LOCAL GOVERNMENT OFFICIAL INFORMATION AND MEETINGS ACT Request: 2024-57

“Can you provide me with a copy of all the correspondence pertaining to the above matter [Lincoln Road 2021 resurfacing project], which should include the following:

I draw your attention to document 6, a report prepared by Calibre Consulting Limited in July 2021. The report reviews the footpath, and driveway angles and refreshes the flood risk assessment of Lincoln Road following the completion of the road resurfacing. This report does not appear to have been released previously.

Flowpaths for Floodwater from the Culvert Near No. 42 Lincoln Road

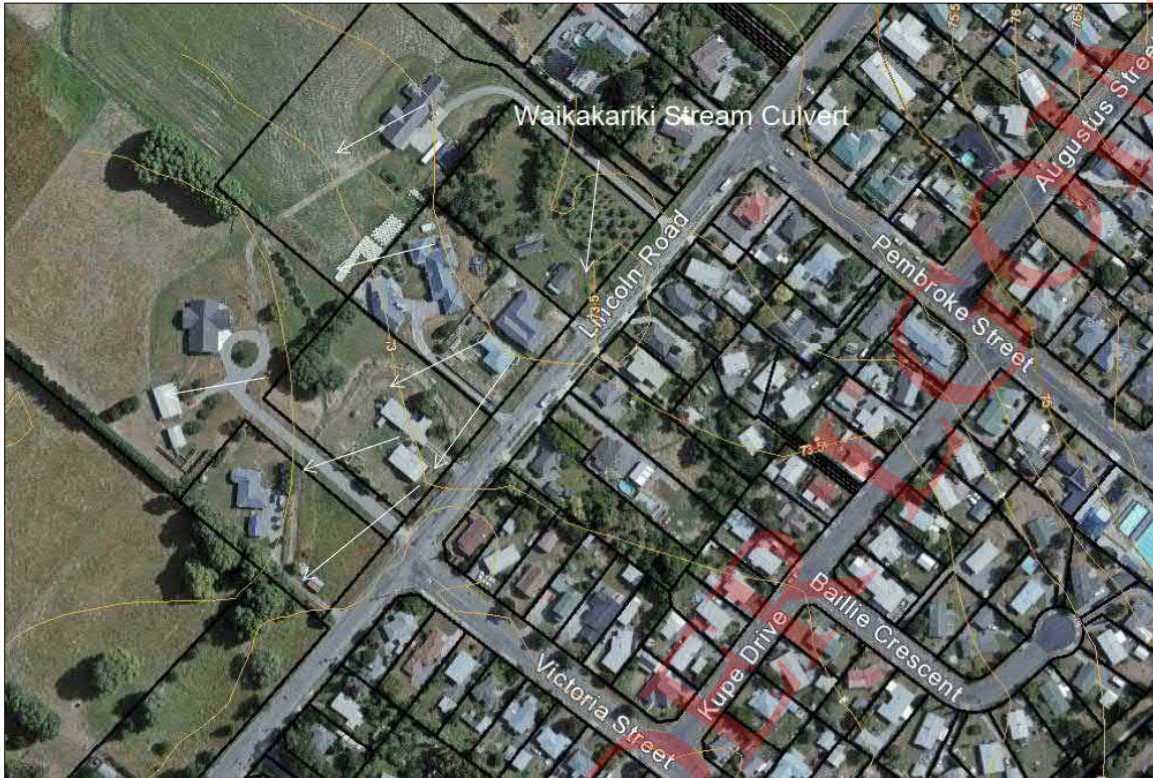
The question to be answered is: does the raising of the crown of the road by 150mm (approximately) increase the risk of flooding for properties on the western side of the road, and specifically No.'s 42 and 48 Lincoln Road?

The major factor affecting the potential for a flood event that affects properties on the western side of Lincoln Road, is the Waikakariki Stream and the culvert under Lincoln Road. If this culvert is blocked or if a storm event exceeds the design capacity of the culvert, there will be flooding in the local area.

The contours, show that there is a "basin" at the entrance to the culvert, roughly defined by the contour line of elevation 73.5 metres. In a flood event and if the culvert is blocked, or where the storm event exceeds the capacity of the culvert, the basin will overtop, and floodwater will spread out across the adjoining land. This floodwater will take the preferential flowpath, that is, it will travel down slope at right angles to the contours of the land. The white arrows shown on the aerial photograph are perpendicular to the contour lines and indicate the preferential flowpaths for floodwaters.

If Council wished to alleviate resident concerns, it is suggested that the swale drain/table drain be reformed as a wide shallow “V” drain within properties, at perhaps 2 to 3 metres in width and 100mm to 150mm in depth, and that culverts be installed beneath driveways to ensure that flows are unimpeded for the full length of the widened road. A swale will provide a defined channel for floodwater to follow, and if culverts are provided, this water can be channelled to the Waikakariki Stream near Victoria Street.

Sheet Title
 LAYOUT AND SECTION
 OPTION 1
 (PREFERRED OPTION)

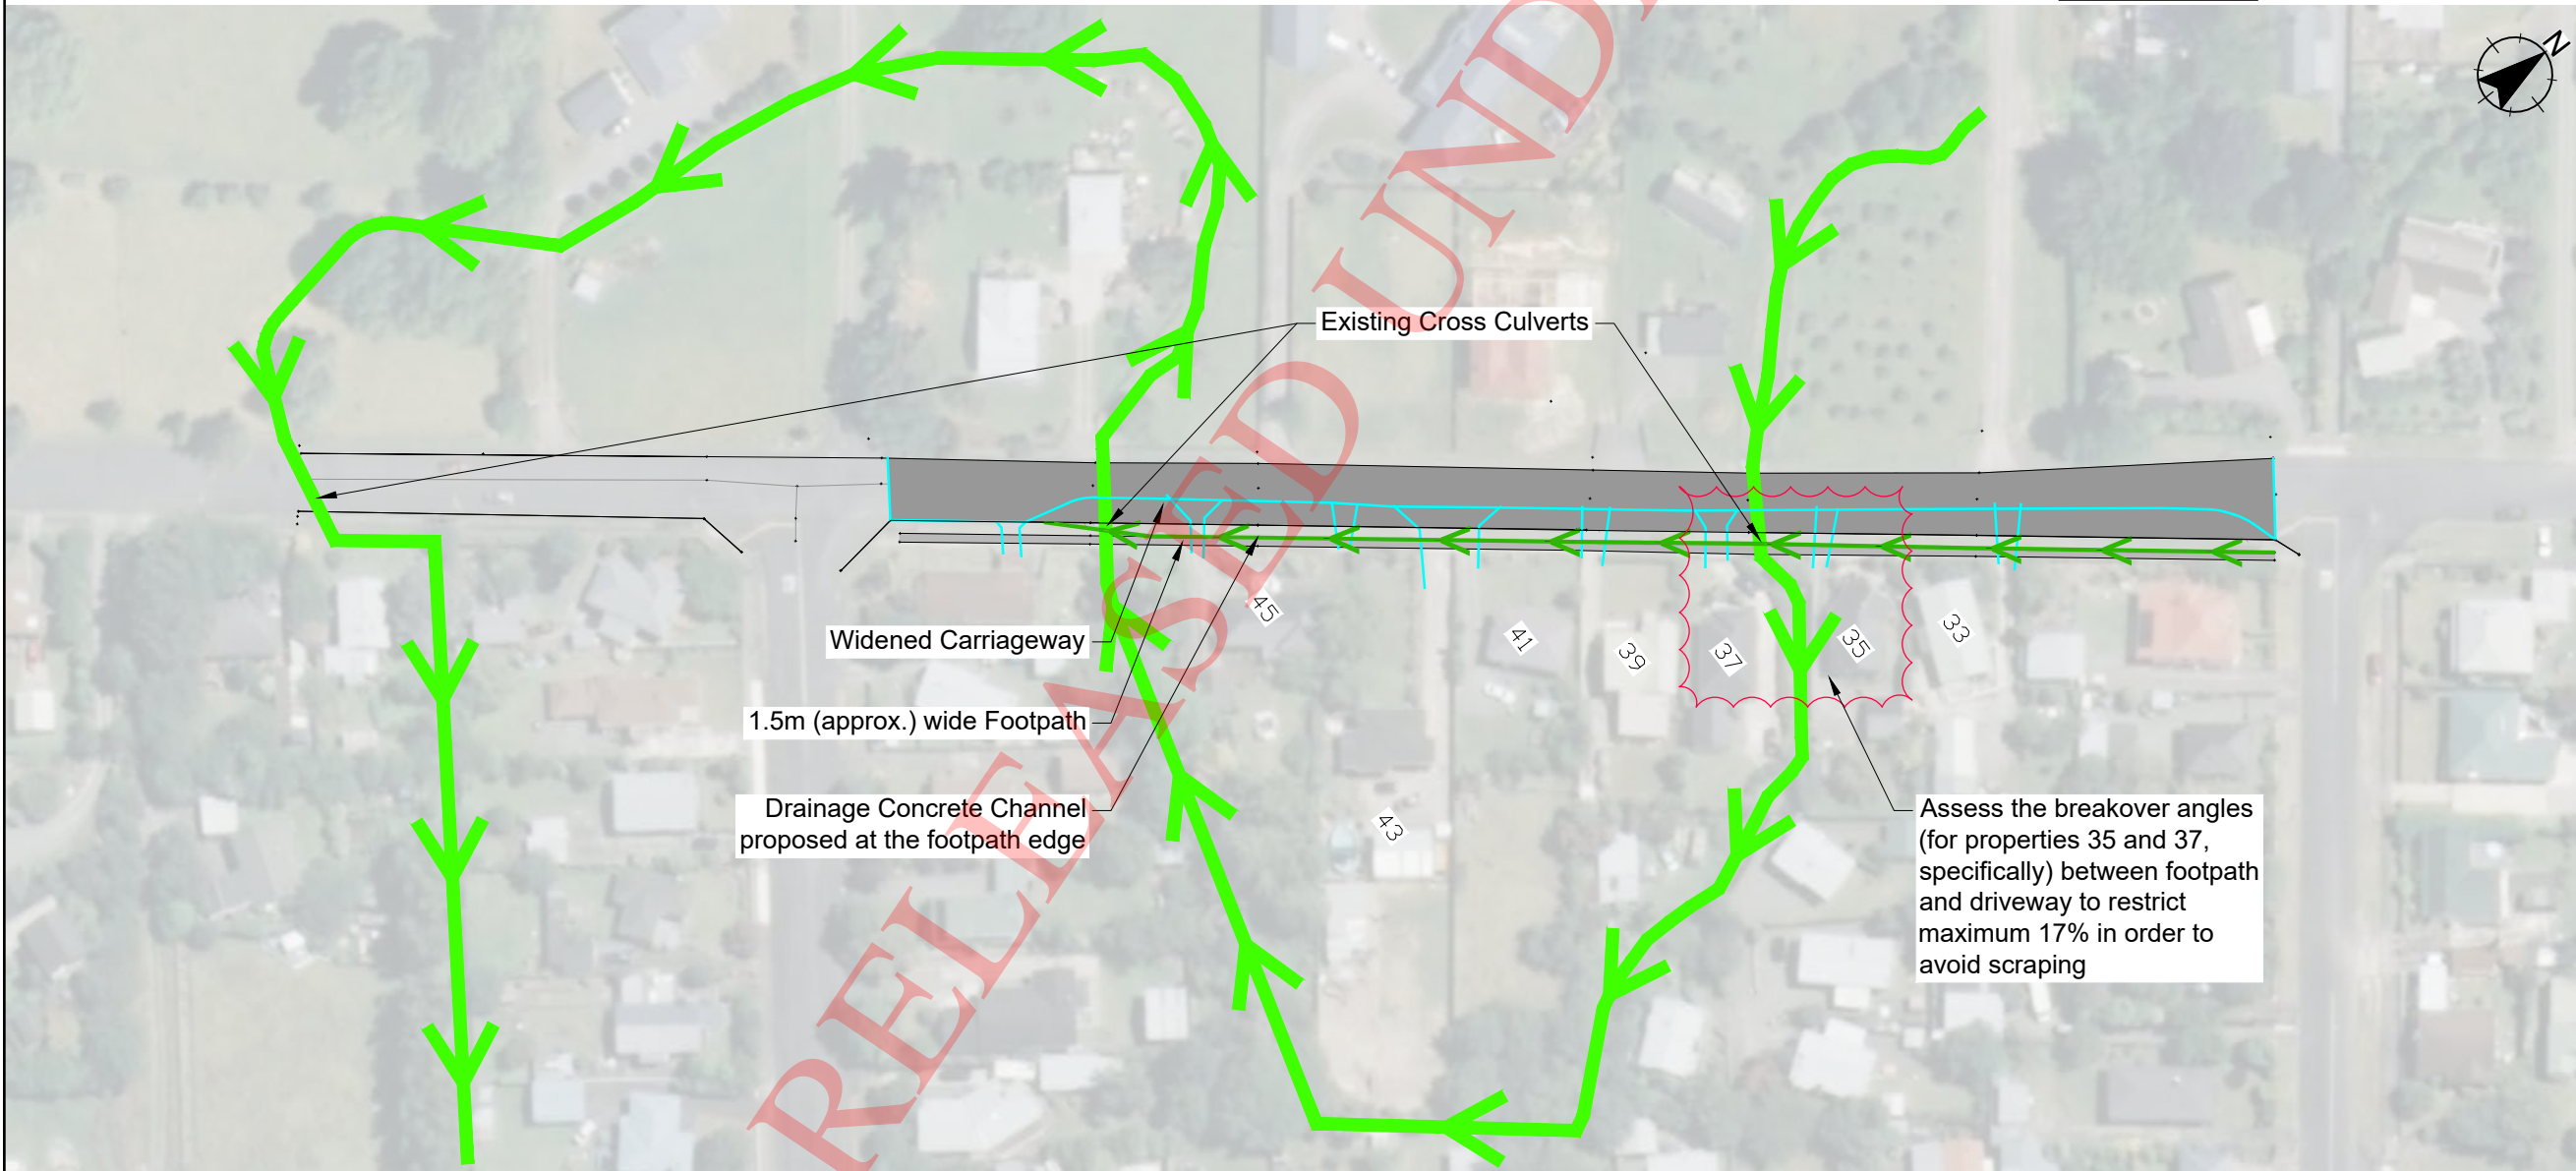
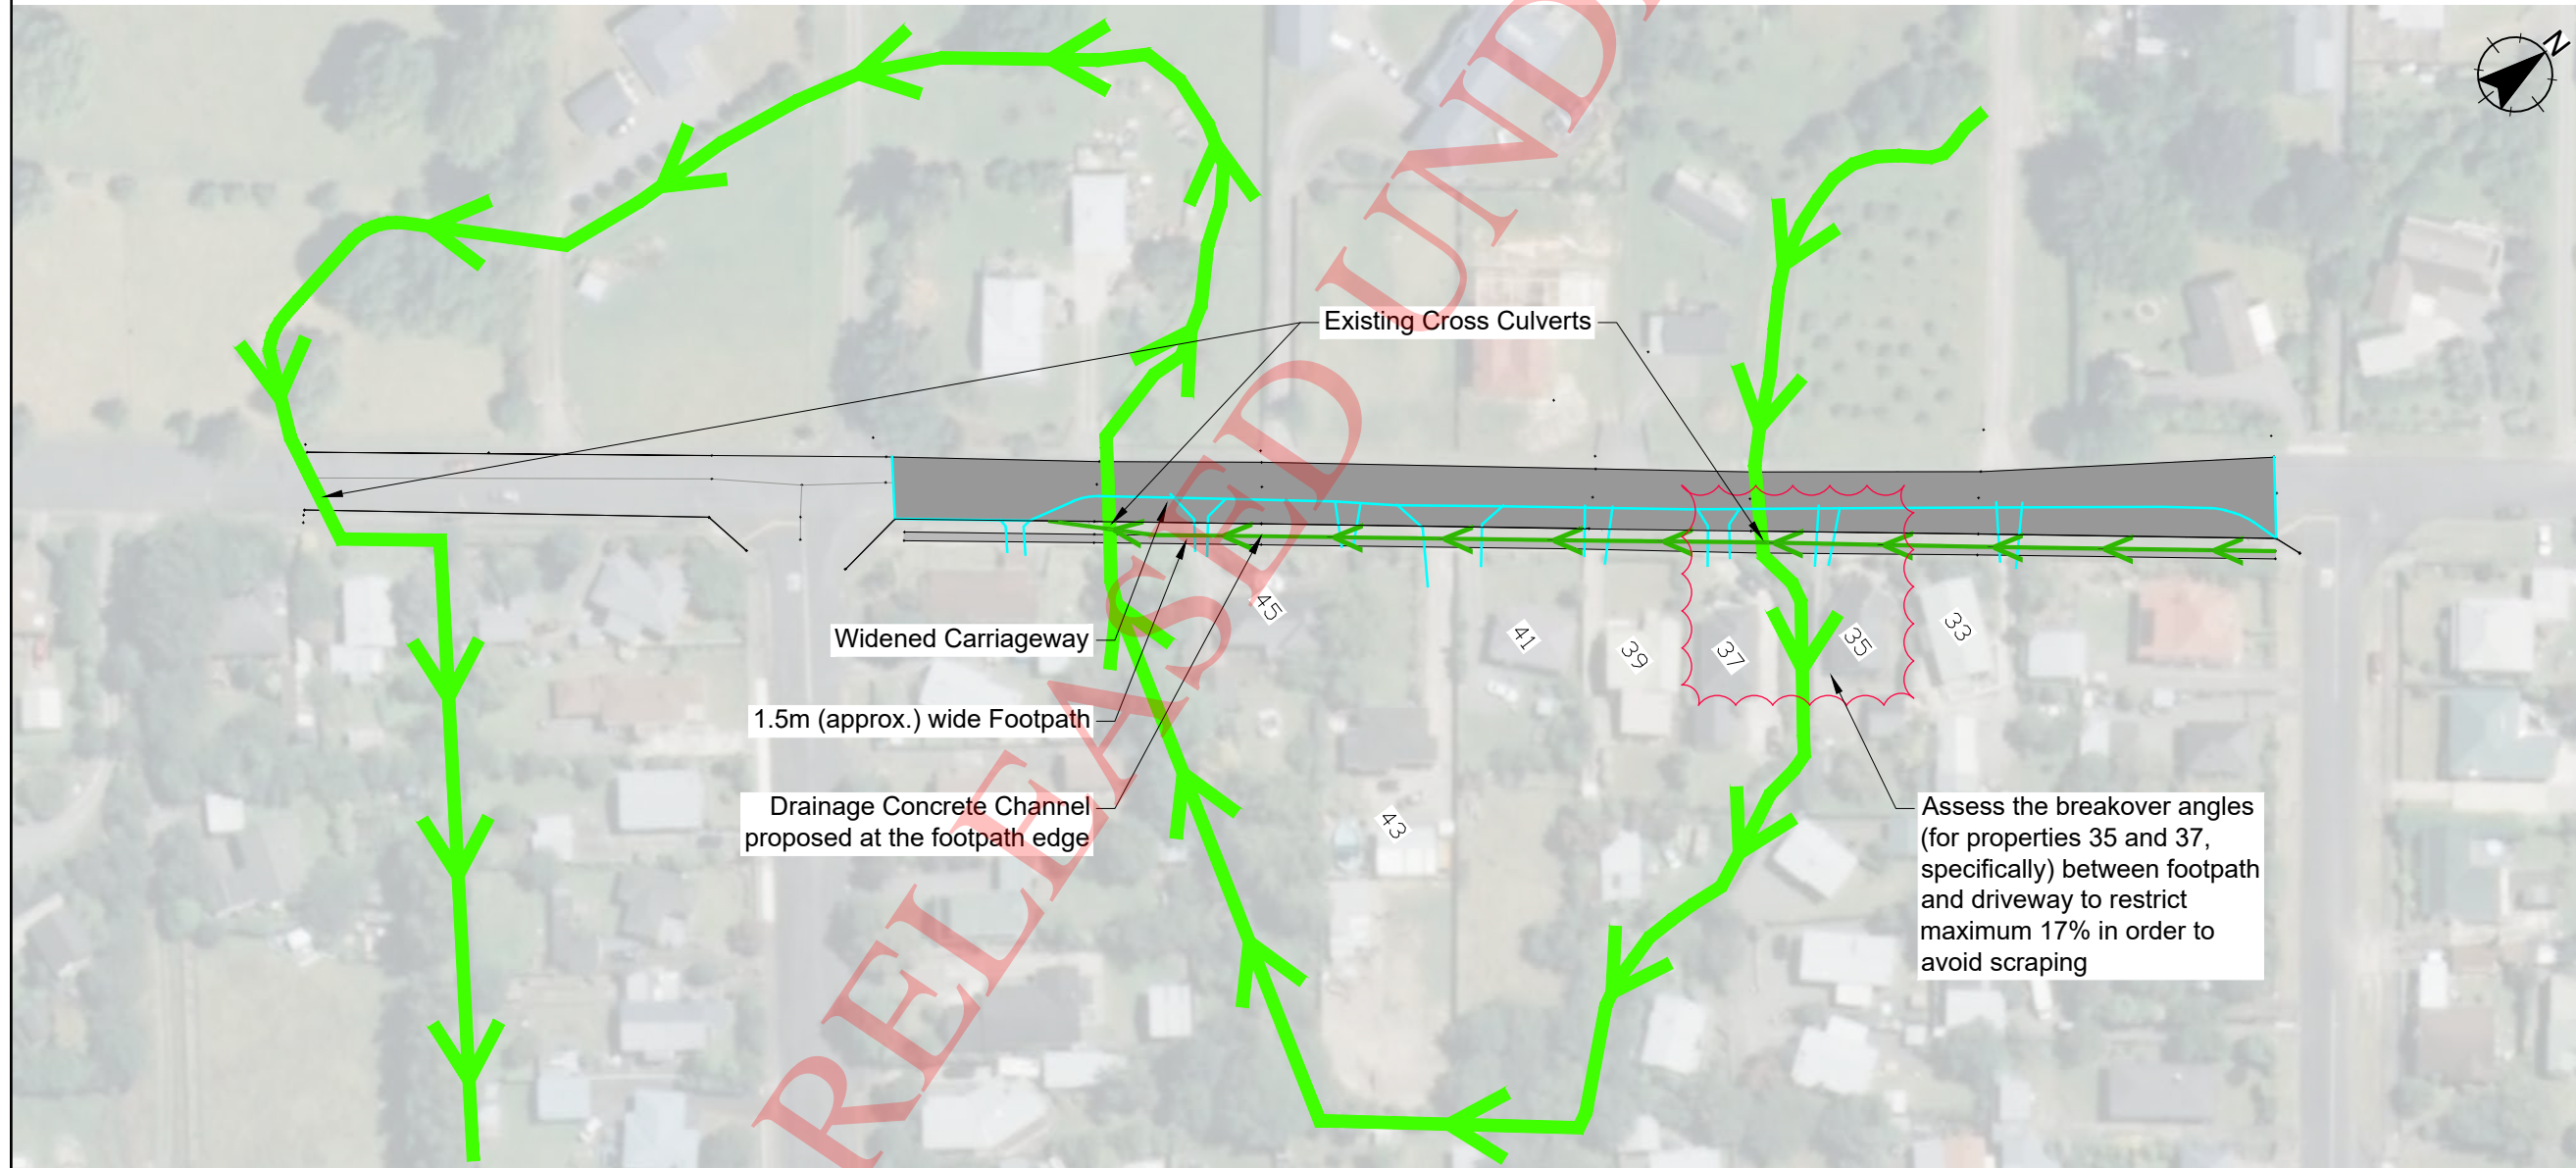
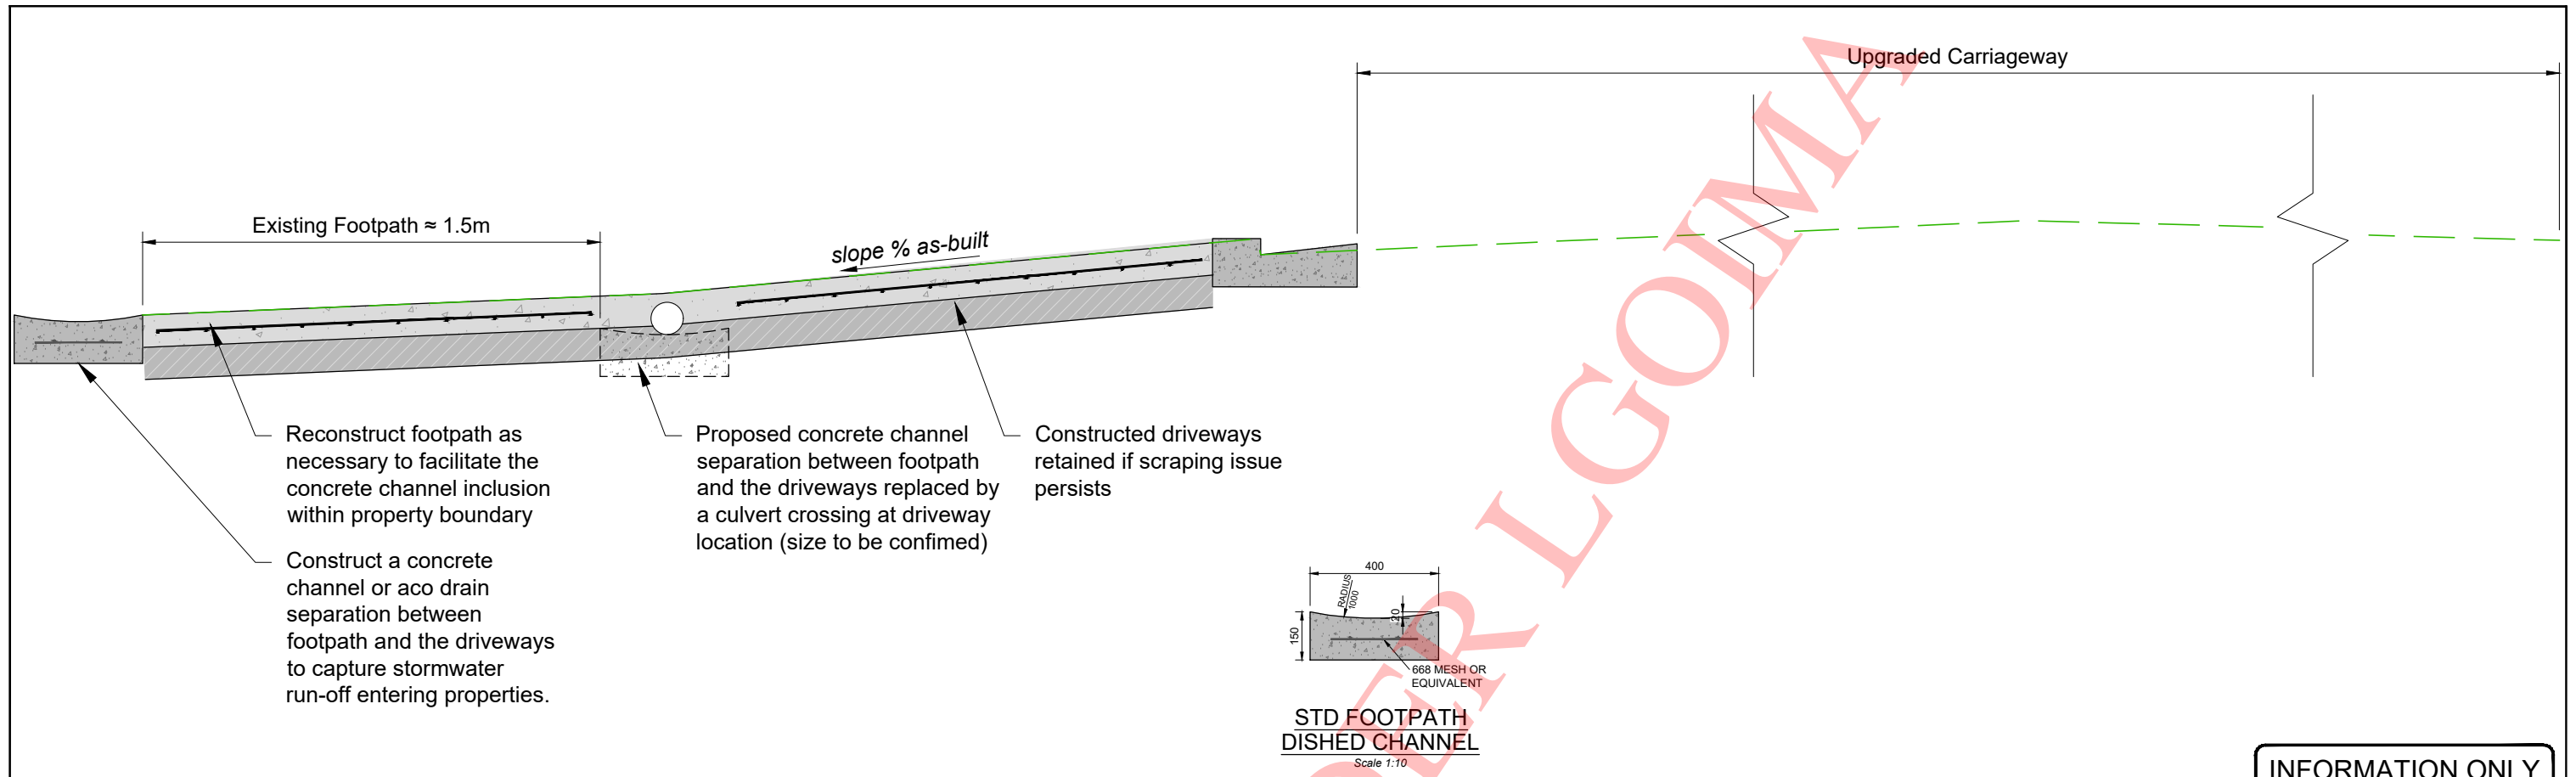
This option would alleviate the build-up of water in the valley created by the grassed berm and footpath; however, site observations show that the slope on the existing driveways is from the kerb and channel to the property boundaries. As such the section of the driveway on the property side of the slot drain would still discharge surface water into private property, as well as potentially damming water inside properties that would otherwise have flowed across the concrete footpaths.

In summary the *Removal and Reconstruction of Driveways* is the recommended option, noting that a topographical survey will be required to provide sufficient information for the detailed design.

Reconstruct footpath to drain away from property boundary
 - change of crossfall to be approved by Engineer)
 - Reinforcement required only at driveway crossings

Reconstruct driveways to accommodate concrete channel between driveway and footpath
